Product Change Notice

(PCN Tracking Number: EE-QR-220301-01)

Customer:	ALL Customers
Renesas Product Type:	RA2E2 Group (Refer to Product list on last page)
Description of Change:	<p>The applicable products (MCU Ver.1) listed in the Product List have restrictions and precautions on the I²C / I3C bus interface. Regarding the restrictions and precautions of MCU Ver.1, the workarounds and precautions have already been described in RA2E2 Group User's Manual Hardware Rev.1.00 (R01UH0919EJ0100). However, in order to improve the function of the I²C / I3C bus interface, the products were revised and the MCU version was changed from MCU Ver.1 to MCU Ver.2. For details of the changes, please refer to pages 4-17. The software workarounds of MCU Ver.1 can be executed on MCU Ver.2 without any changes.</p>
Reason for Change:	Improved I ² C / I3C bus interface function
Identification:	Change of the last digit of the booking part numbers from 0 to 1 in comparison between MCU Ver.1 and MCU Ver.2 (refer to page 3)

#1 : I²C master; Operation when writing transmission data

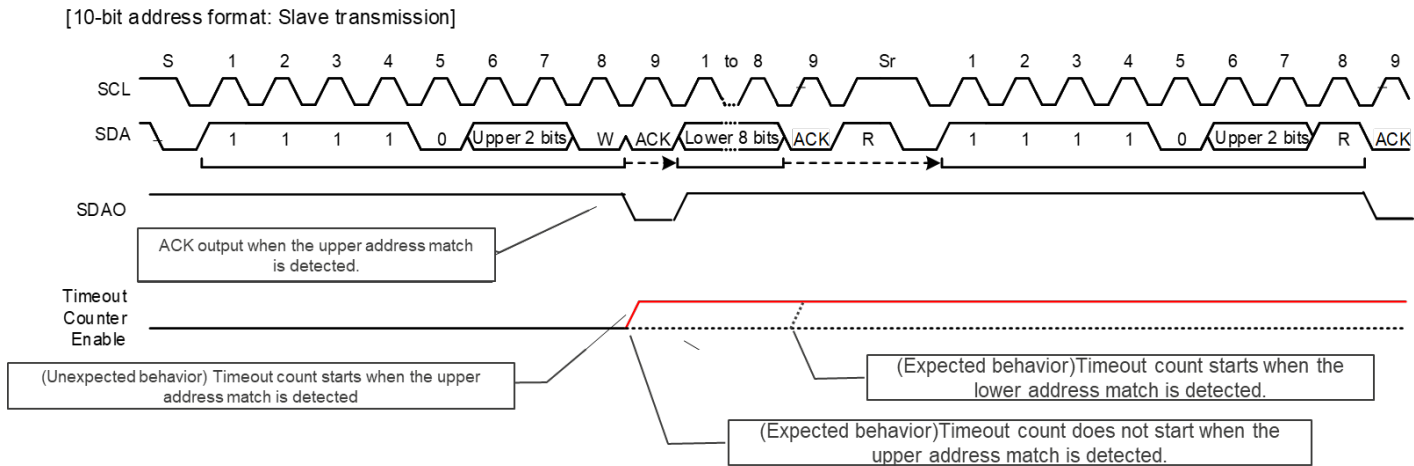
In MCU Ver.1, when the output timing of the first data of the frame and the transmission data write timing are conflicted, the transmission of the first data to be transmitted (b7) will start with a deviation of 1 bit. MCU Ver.1 requires the software workaround when writing transmission data, but MCU Ver.2 does not require the software workaround.

Note: The following processing is required when checking NTST.TDBEF0 = 1 in Steps [3] and [4] of the I2C master transmission flowchart as shown in Figure 25.104.

After confirming NTST.TDBEF0 = 1, confirm that PRSTDBG.SCILV = 0 (check the status of SCL) before writing the transmission data.

- If BITCNT.BCNT = other than 0 after confirming NTST.TDBEF0 = 1, write the transmission data immediately
- If BITCNT.BCNT = 0 after confirming NTST.TDBEF0 = 1, check that BST.TENDF = 1 and PRSTDBG.SCILV = 0 (check the status of SCL) before writing the transmission data.

Note: [MCU Ver.1 has the following restrictions and workarounds. These restrictions and workarounds are not required for MCU Ver.2.](#)

The following processing is required when checking NTST.TDBEF0 = 1 in Steps [3] and [4] of the I2C master transmission flowchart as shown in Figure 25.104.

After confirming NTST.TDBEF0 = 1, confirm that PRSTDBG.SCILV = 0 (check the status of SCL) before writing the transmission data.

- If BITCNT.BCNT = other than 0 after confirming NTST.TDBEF0 = 1, write the transmission data immediately
- If BITCNT.BCNT = 0 after confirming NTST.TDBEF0 = 1, check that BST.TENDF = 1 and PRSTDBG.SCILV = 0 (check the status of SCL) before writing the transmission data.

#3 : I²C slave; ACK output operation when 10-bit address communication and the lower address mismatch is detected

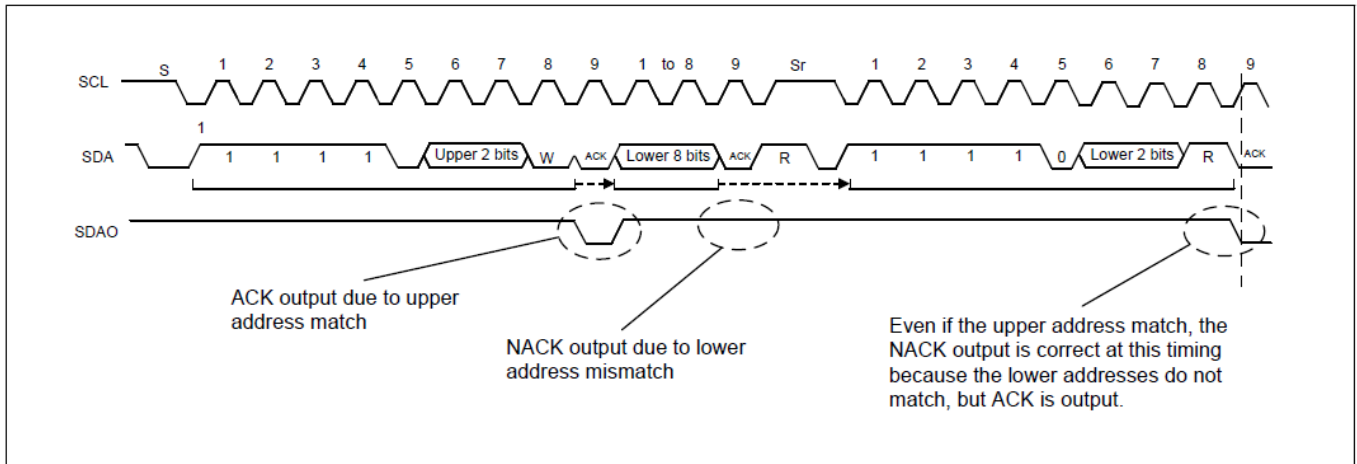
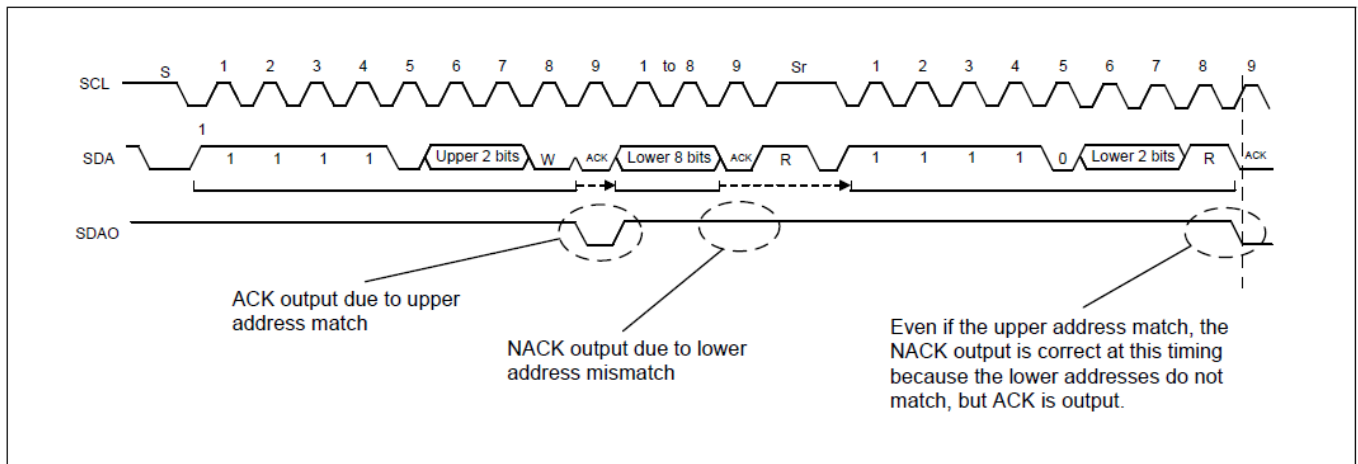
MCU Ver.1 has the following restrictions and workarounds when using 10-bit address communication. The restrictions and workarounds are not required for MCU Ver.2

When multiple I²C slaves are connected to the I²C bus and there is a possibility that an I²C Slave other than this module will NACK for the upper address / R after Repeated START, there are the following restrictions and workarounds.

- Work around : Set the upper 2 bits of the 10-bit address assigned to this module to a value different from other Slave. If the address is exhausted and cannot be set to a different value, use restriction (1).
- Restriction (1) : 10-bit address not available.
- Restriction (2) : After the ACK response in the red circle in the above figure, none of the slaves respond to data, so the SDA keeps the high level and the I²C Master receives the 0xFF data. In the case of a system that can handle 0xFF as abnormal data, 0xFF is read and discarded on the I²C Master side. If 0xFF is valid data, use restriction (1).

MCU Ver.1 has the following restrictions and workarounds. The restrictions and workarounds are not required for MCU Ver.2.

When multiple I²C slaves are connected to the I²C bus and there is a possibility that an I²C Slave other than this module will NACK for the upper address / R after Repeated START, there are the following restrictions and workarounds.

- Work around : Set the upper 2 bits of the 10-bit address assigned to this module to a value different from other Slave. If the address is exhausted and cannot be set to a different value, use restriction (1).
- Restriction (1) : 10-bit address not available.
- Restriction (2) : After the ACK response in the red circle in the above figure, none of the slaves respond to data, so the SDA keeps the high level and the I²C Master receives the 0xFF data. In the case of a system that can handle 0xFF as abnormal data, 0xFF is read and discarded on the I²C Master side. If 0xFF is valid data, use restriction (1).

4 : I3C slave; Arbitration operation when Dynamic Address is assigned by the ENTDAAC command

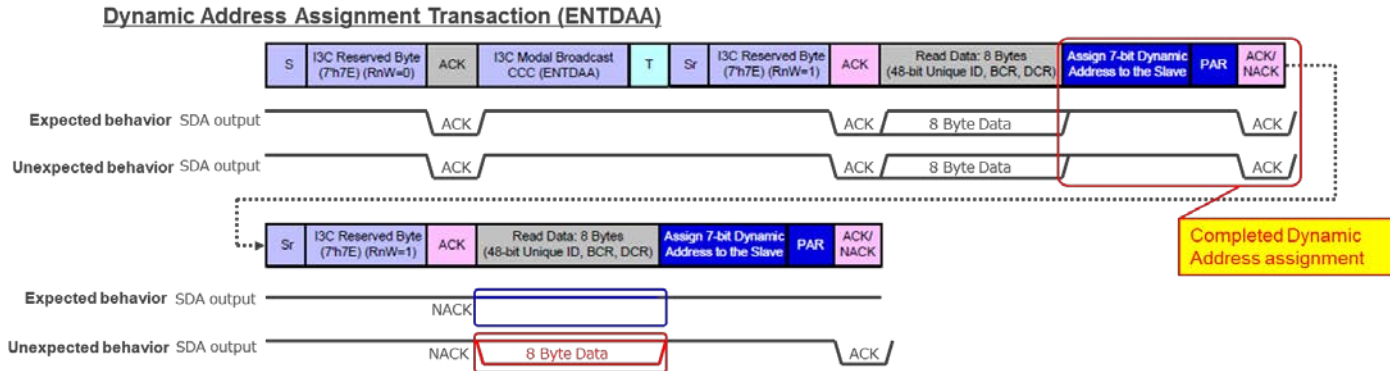
In MCU Ver.1, if a dynamic address is assigned by the ENTDAAC command in I3C slave mode, I3C will participate in dynamic address arbitration in response to the ACK response of other slaves even after the dynamic address assignment.

MCU Ver.1 requires the restrictions and workarounds when assigning dynamic address, but the restrictions and workarounds are not required for MCU Ver.2.

Note: When multiple I3C (I3C Slave) are connected on the I3C Bus assign Dynamic Addresses in the following order.

1. Set the SDCTPIDH and SDCTPIDL registers (6 Bytes) of the I3C (I3C Slave) to a value (All 1 etc.) that has a lower priority than other Slave Devices by Dynamic Address Arbitration.
2. After setting the Static Address in the I3C (I3C Slave), assign the Dynamic Address using the SETDASA /SETAASA command.
3. Assign a Dynamic Address to an I3C Slave Device other than the I3C (I3C Slave) using the ENTDAAC command.

MCU Ver.1 has the following restriction and workaround. This restriction and workaround are not required for MCU Ver.2.

Note: When multiple I3C (I3C Slave) are connected on the I3C Bus assign Dynamic Addresses in the following order.

1. Set the SDCTPIDH and SDCTPIDL registers (6 Bytes) of the I3C (I3C Slave) to a value (All 1 etc.) that has a lower priority than other Slave Devices by Dynamic Address Arbitration.
2. After setting the Static Address in the I3C (I3C Slave), assign the Dynamic Address using the SETDASA /SETAASA command.
3. Assign a Dynamic Address to an I3C Slave Device other than the I3C (I3C Slave) using the ENTDAAC command.

Figure 25.96 Example of error recovery operation flowchart for I3C Master

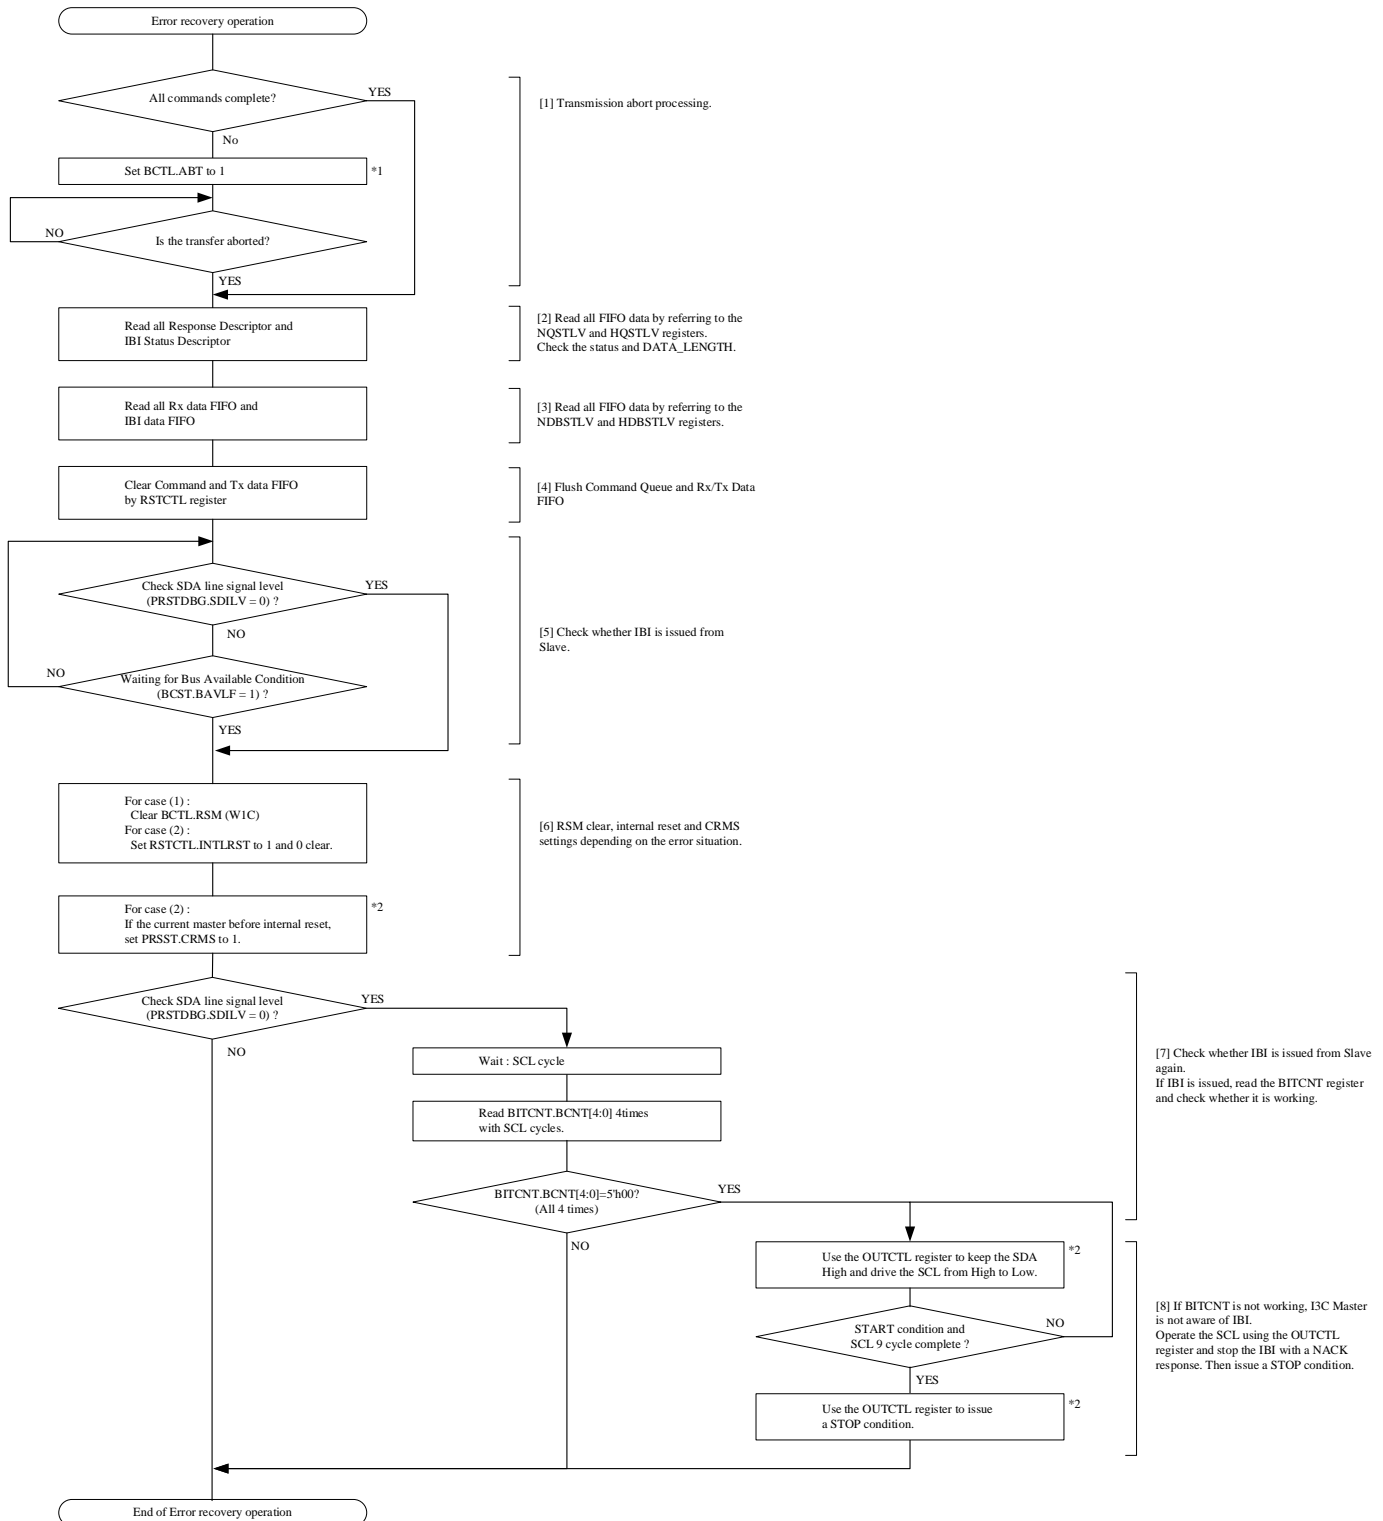
In order to improve the complexity of the error recovery flow, MCU Ver.2 is revised the circuit so that I3C will be suspended (BCTL.RSM becomes 1) when an error occurs. After I3C is suspended, the application must write the value 1 to the BCTL.RSM bit to resume I3C operation and recover from suspended state.

In MCU Ver.2, the error recovery flow shown in Figures 25.96 and Figures 25.97 are simplified by the above improvements.

Figure 25.96 and Figure 25.97 show the error recovery flow.

Figure 25.96-2 Example of error recovery operation flowchart for I3C Master

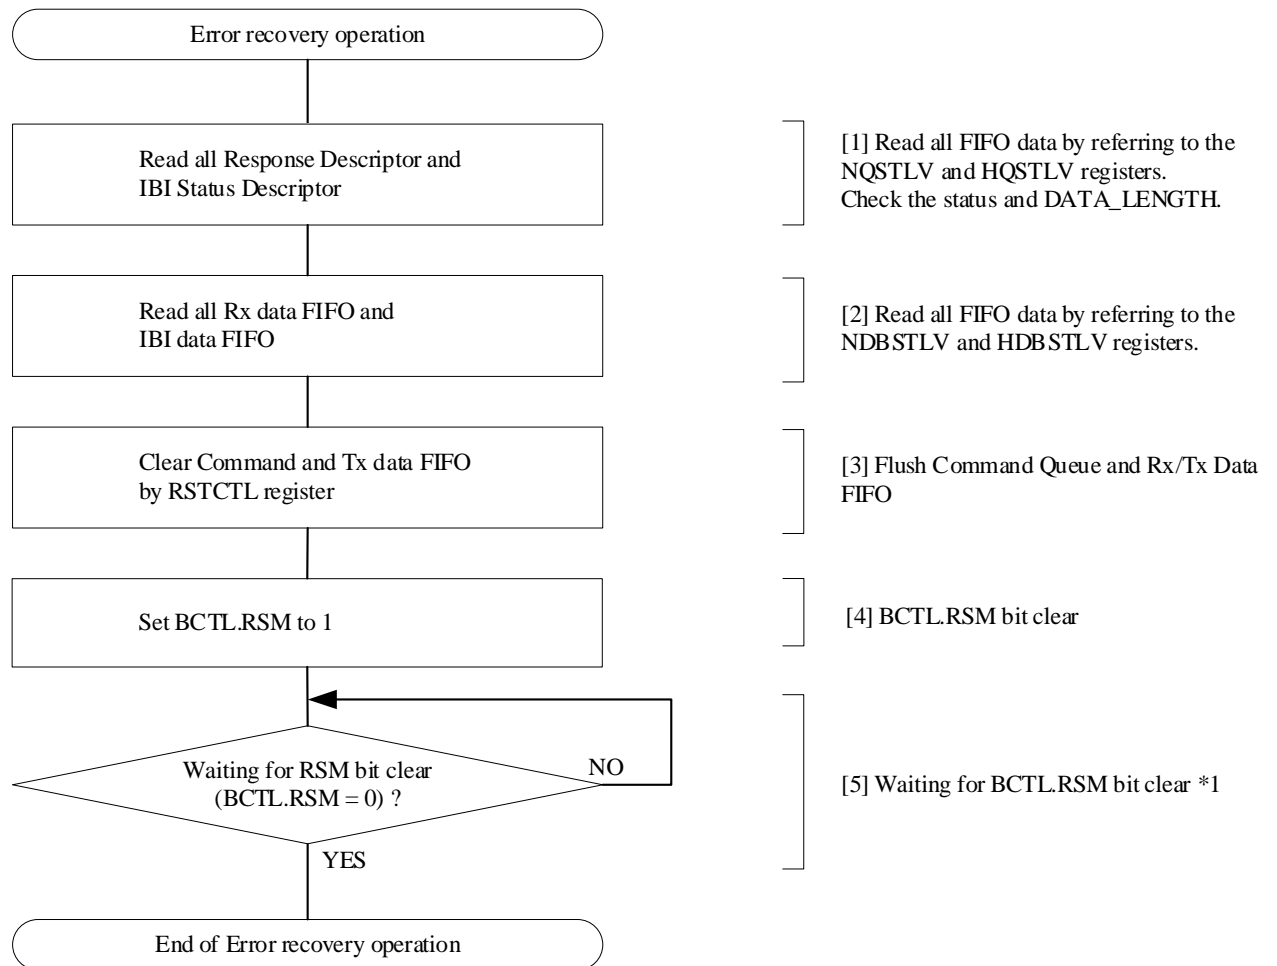
Note: For MCU Ver.2, apply the following error recovery flow.

If an error occurs, I3C will be suspended. (BCTL.RSM becomes 1.) After I3C is suspended, the application must write the value 1 to the BCTL.RSM bit to resume I3C operation and recover from the suspended state.

Figure 25.96-2 and Figure 25.97-2 show the error recovery flow of MCU Ver.2.

There is no problem even if the error recovery flow of MCU Ver.1 is executed on MCU Ver.2.

Note 1. It is possible to set the Command Descriptor while waiting for the RSM bit to be cleared.
